Gachsaran Polymer Industries Company HDPE Plant		
	LCP and Junction Box Layout, Arrangement and Wiring Drawing for Refrigerator Package		 
PO No.: GPIC-PT-MA-PO-000-3029	Document Number: VD-GPIC-MA-3029-3029-0046	Rev. 00	Page 1 of 14

LCP and Junction Box Layout, Arrangement and Wiring Drawing for Refrigerator Package

REV.	DATE (DD.MM.YY)	Purpose of Issue	Prepared	Checked	Approved
00	14.Jan.26	IFR	R.G	F.T	A.M
DRAWING TITLE:		Gachsaran Polymer Industries Company HDPE Plant			
DRAWING NO.		SCALE: 1:1			
VD-GPIC-MA-3029-3029-0046		REV. SHEET NO. SIZE			
		00 4 OF 14 A3

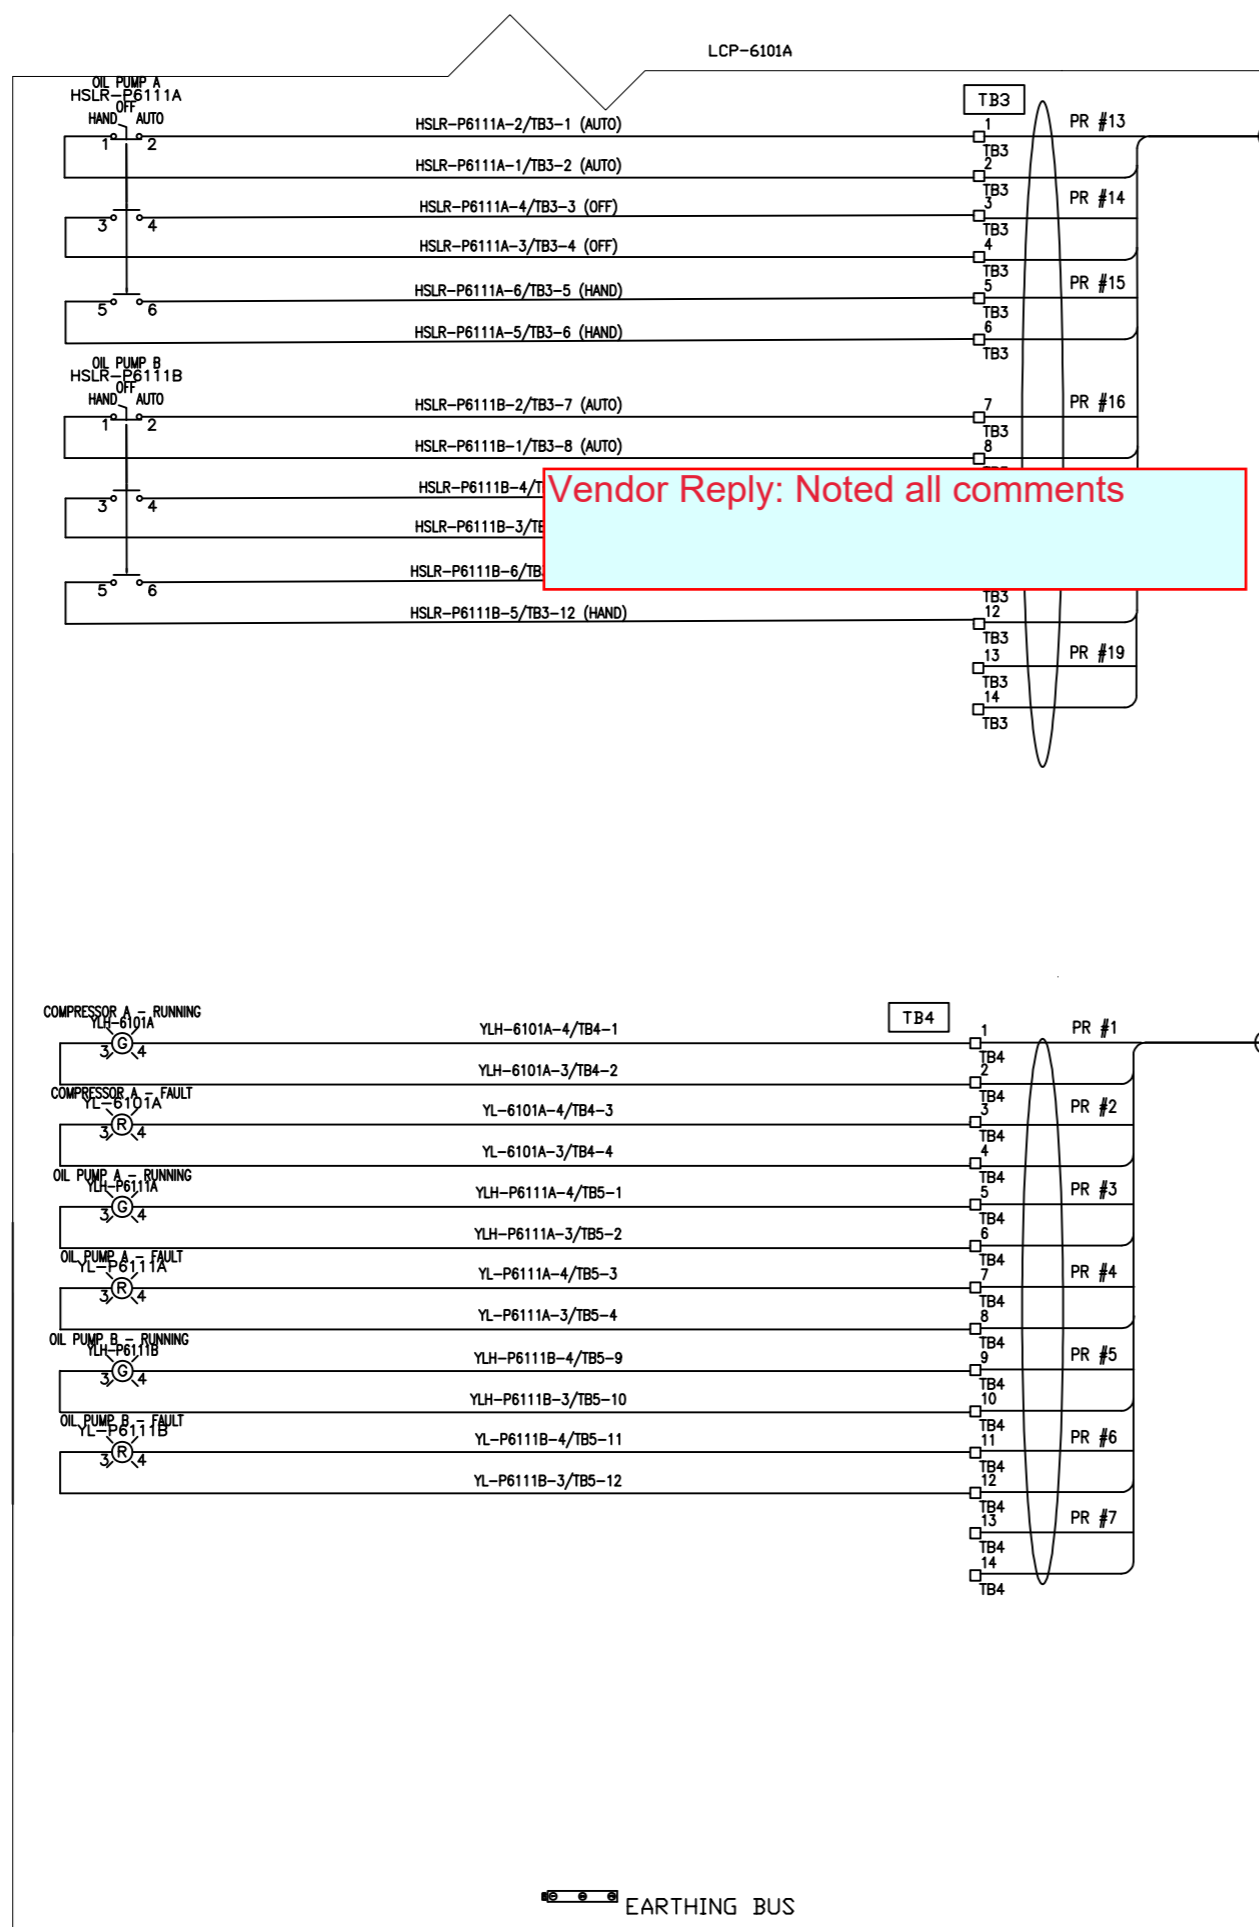
Delete it.

Add cable tag: UCP-LCP-6101A-1

All cable glands on LCP and JBs shall be supplied by Vendor.

Delete it.

Add cable tag: UCP-LCP-6101A-2

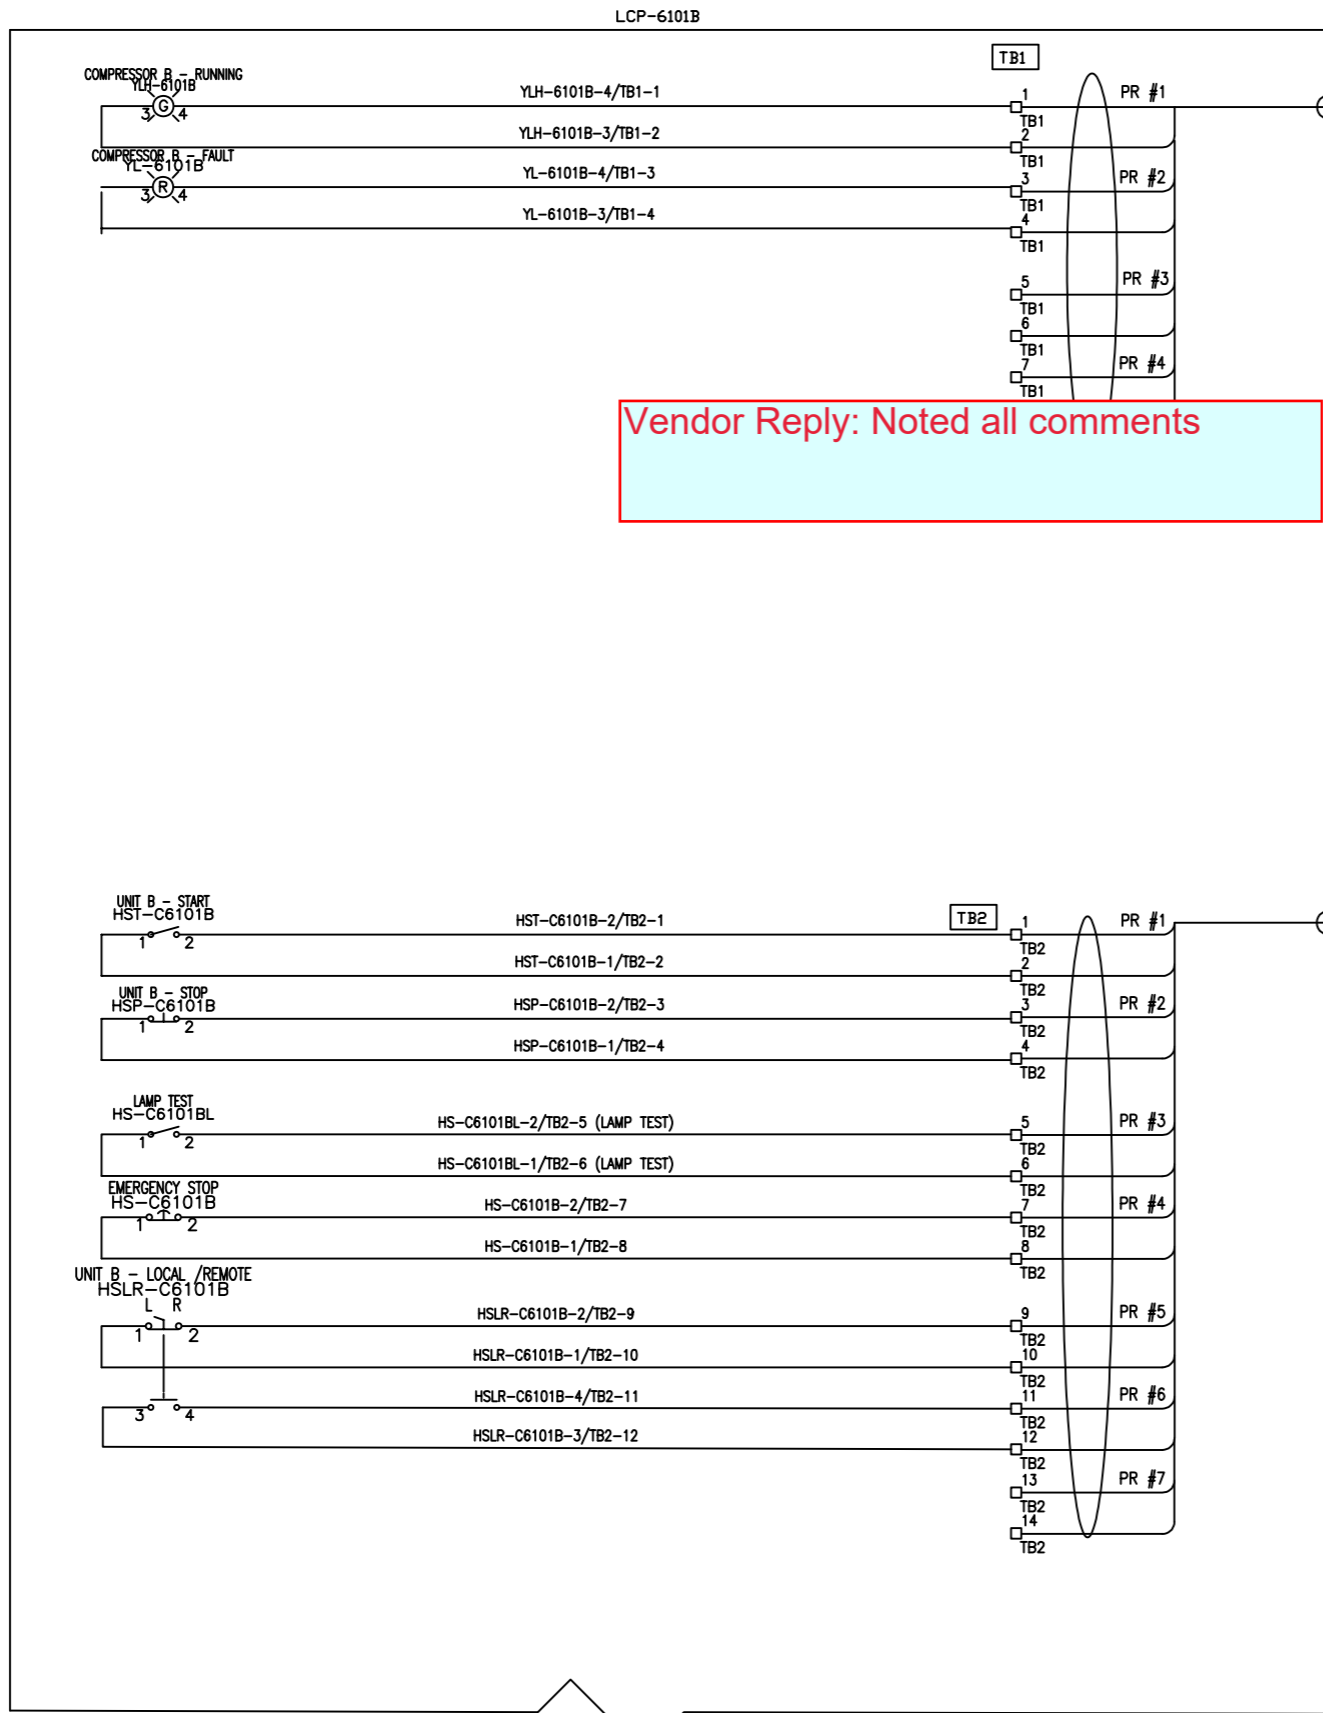
Delete it.

Add cable tag: UCP-LCP-6101B-2

Delete it.

Add cable tag: UCP-LCP-6101B-1

Vendor Reply: Noted all comments

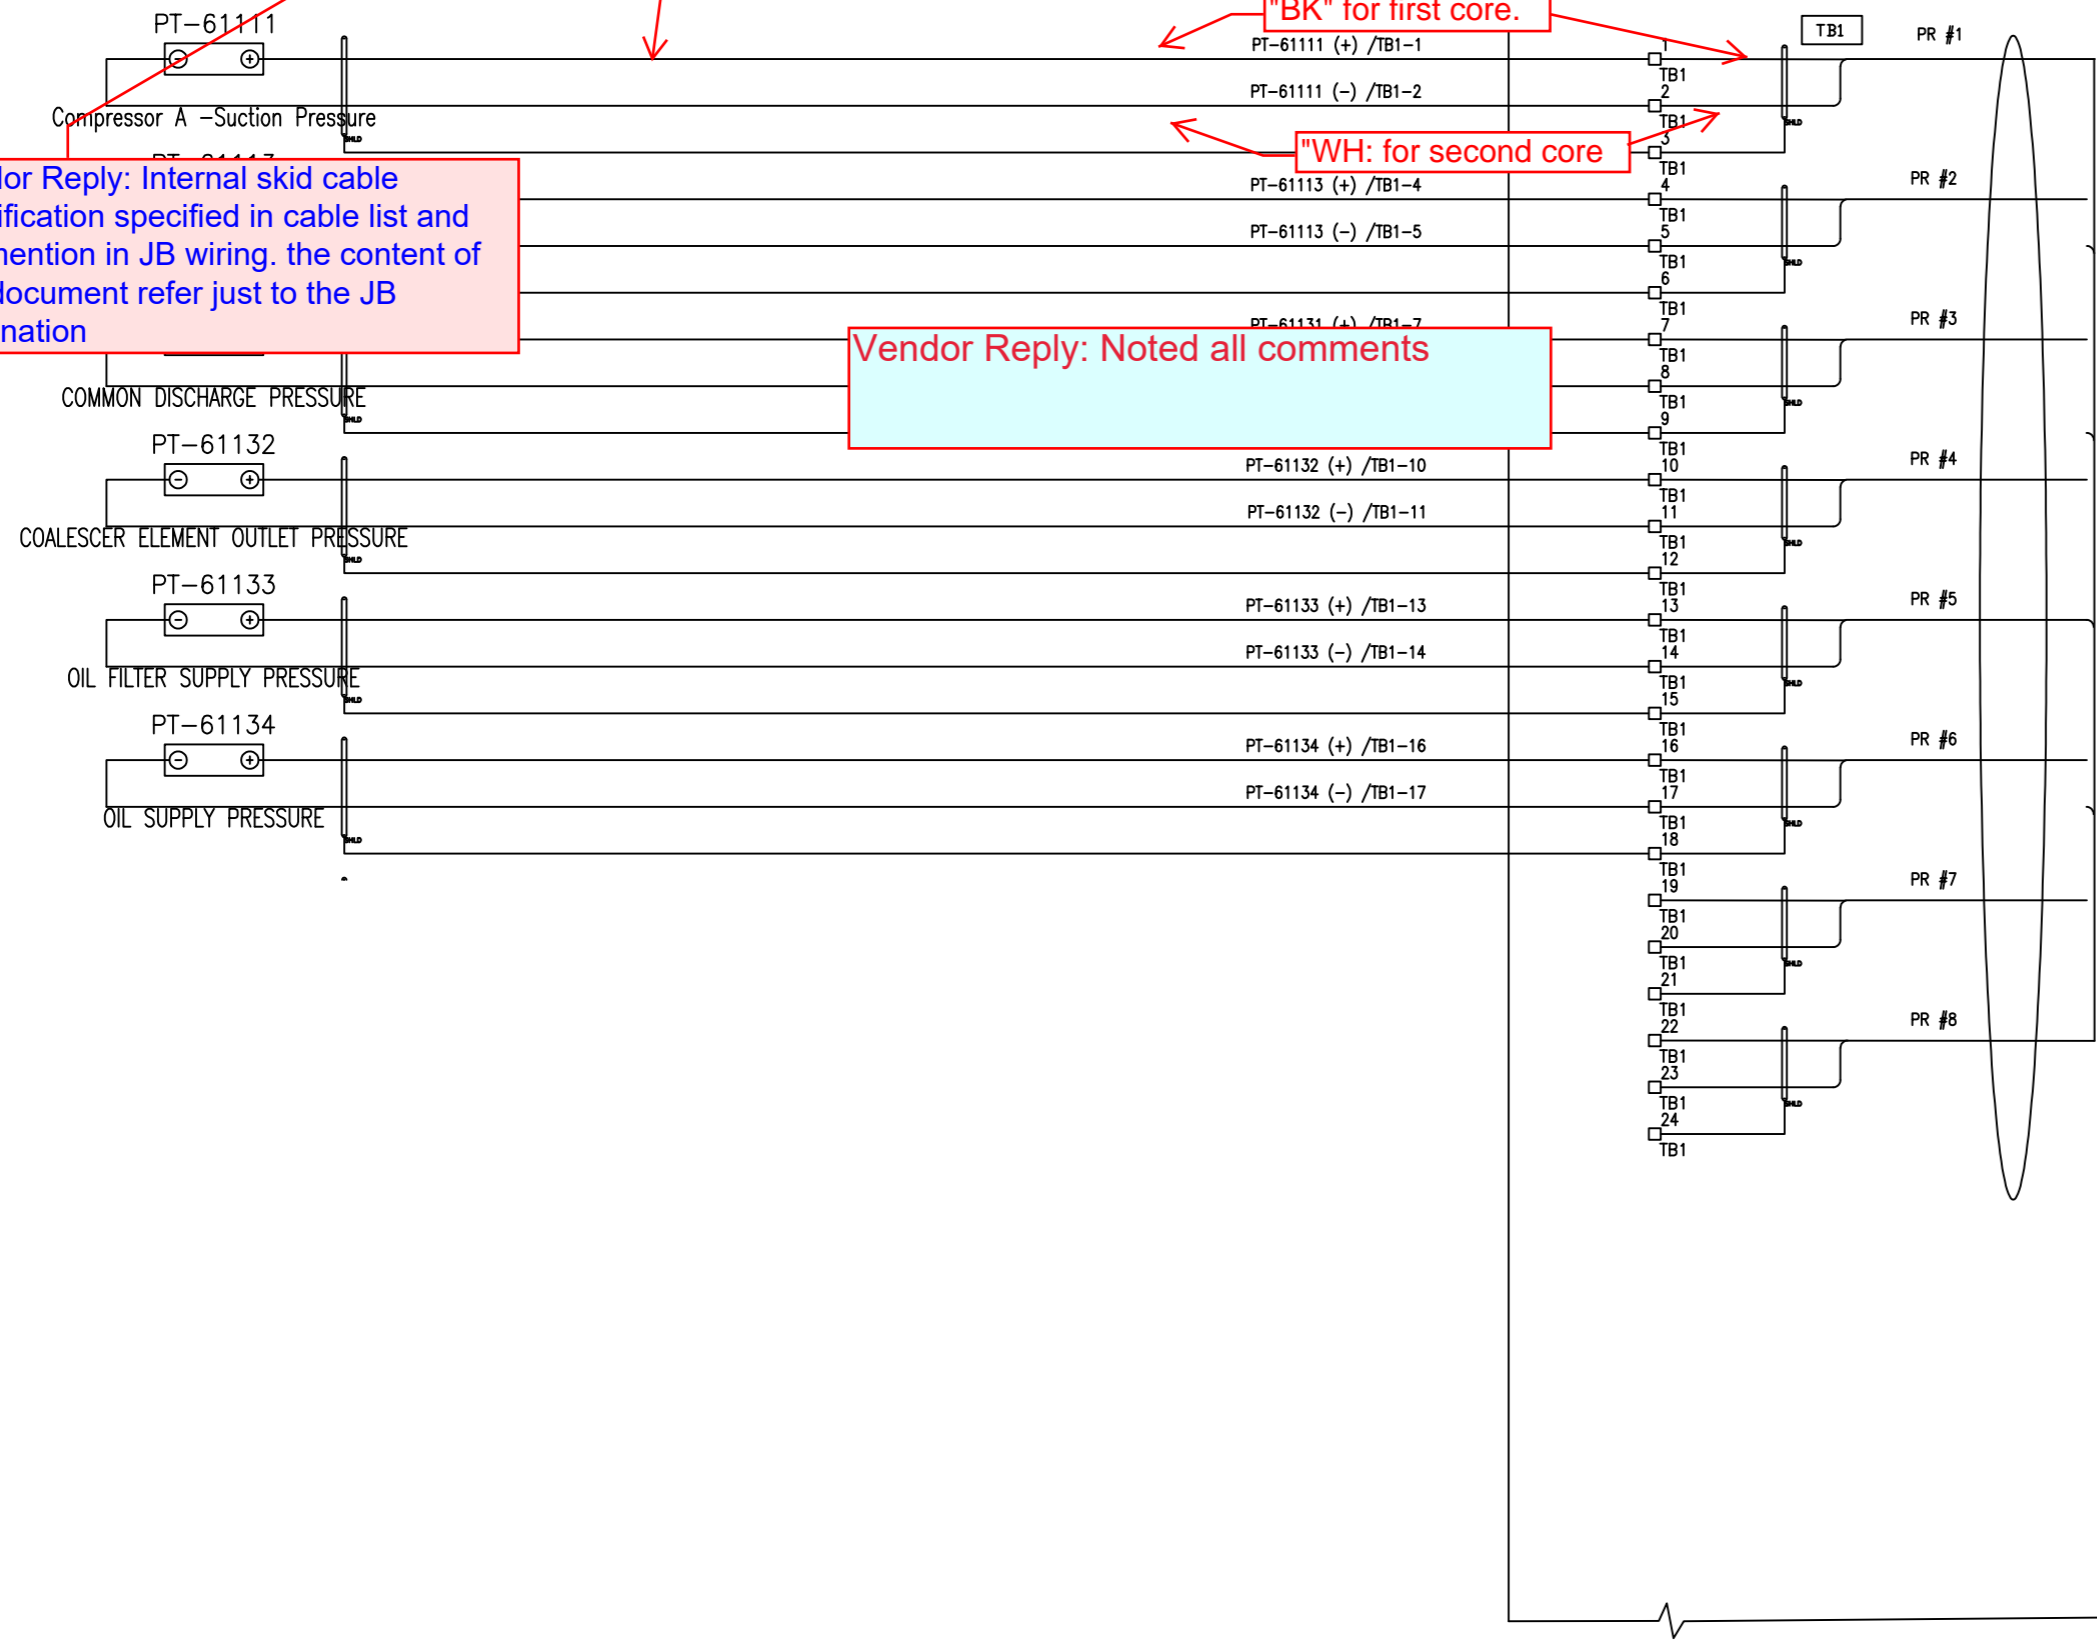
"FRT-01Px1.5mm² OSCR/SWA/IS/BLUE (300/500)"
for all single pair cables.

This comment shall be implemented
for all items in all sheets.

"BK" for first core.

"WH: for second core"

Vendor Reply: Internal skid cable
specification specified in cable list and
not mention in JB wiring. the content of
this document refer just to the JB
termination

Vendor Reply: Noted all comments

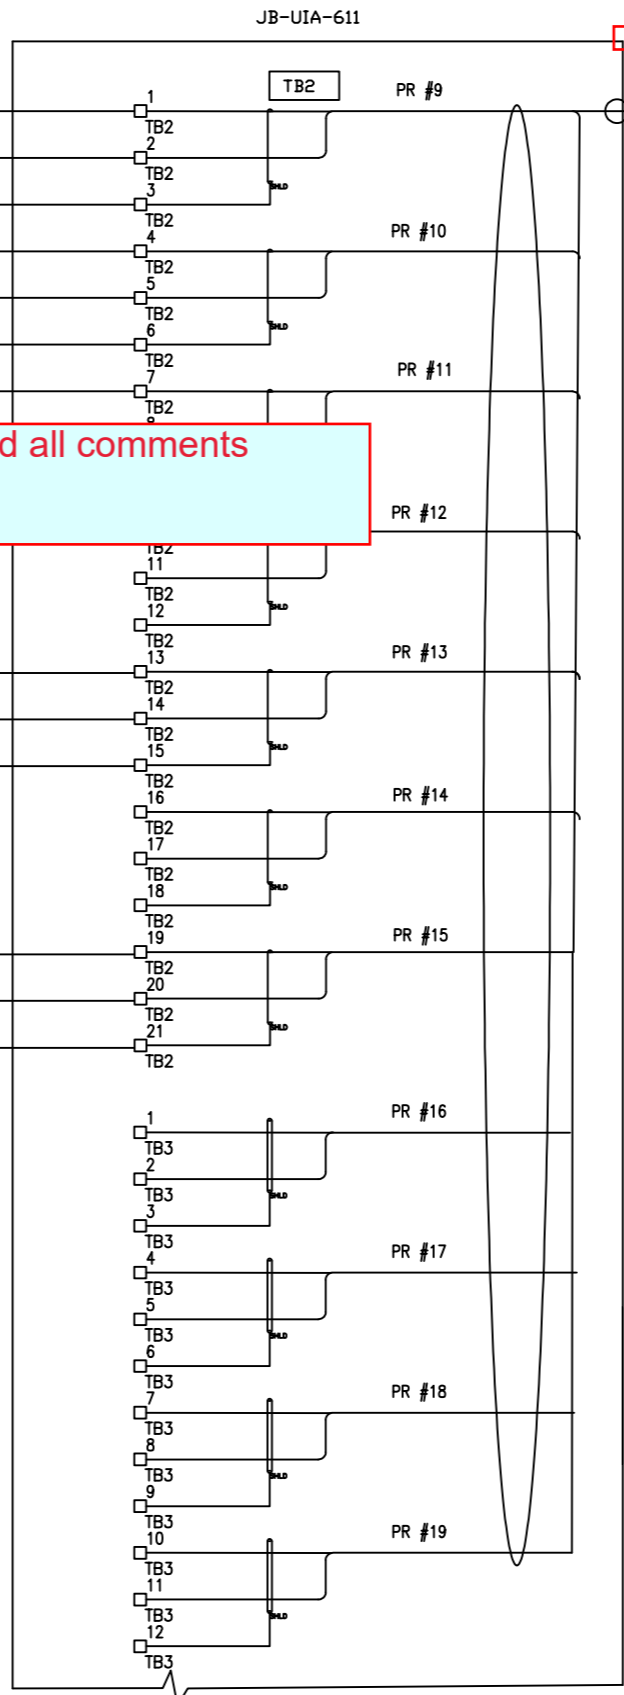
"FRT-01Px1.5mm² OSCR/SWA/IS/BLUE (300/500)"
for all single pair cables.

Delete it.

Add cable tag: IC-UIA-611

Vendor Reply: Noted all comments
